Access Compliance Report

Public Rights-of-Way

(Island Curb Cuts)

| Intersection ID: 8157 | Main Street: N_TRYON_ST | Cross Street: ORR_RD | Location: S |

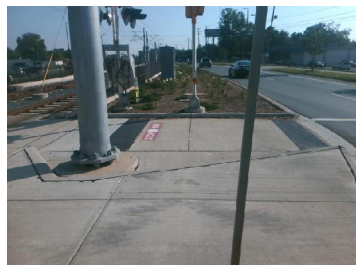
| ADA ID: CE21C91FCE55 | Curb Cut Type: MedianRefuge2 | Initial Pass/Fail: Pass | Overall Compliance: No |

| Compliance | Description | Data | Compliance | Description | Data |
|------------|----------------------|-------|------------|-----------------------------|------|
| N/A | Road 1 X Slope (%) | 2.9 | No | DWS 1 Offset (In) | 42.0 |
| N/A | Road 2 X Slope (%) | 2.7 | No | DWS 2 Offset (In) | 3.0 |

Remove & Replace Detectable Warning System.
